#### **TECHNICAL BULLETIN**

FA-A-0219-A

# Addition of the logo of CC-Link IE Field Network Basic

MELSEC iQ-R series, MELSEC iQ-F series, MELSEC-Q series, MELSEC-L series

# 3 Details on the change

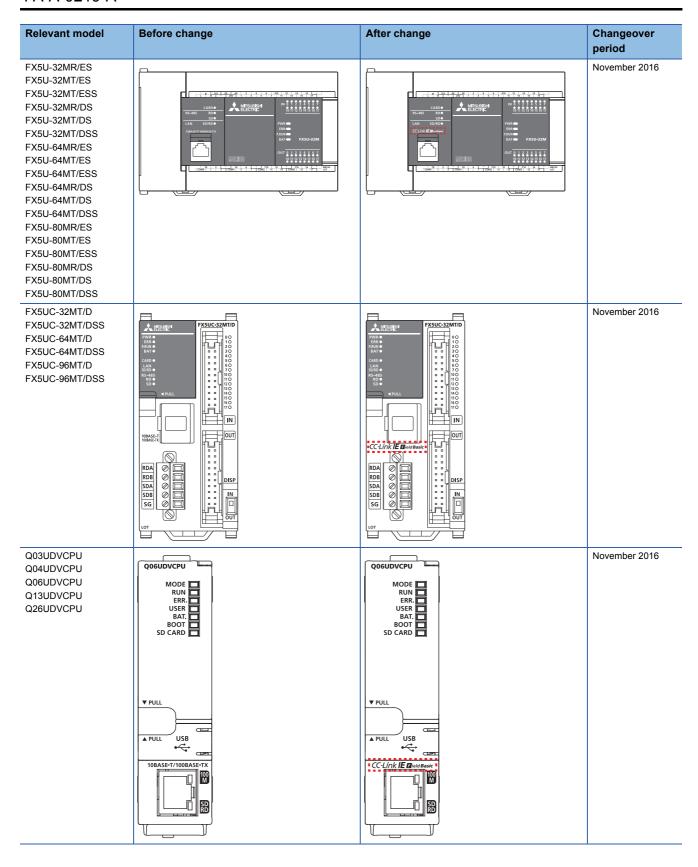
For the CPU modules supporting CC-Link IE Field Network Basic, the logo of 10BASE-T/100BASE-TX is replaced with the logo of CC-Link IE Field Network Basic. Note that the Ethernet function still can be used for these modules even without the 10BASE-T/100BASE-TX logo on them.
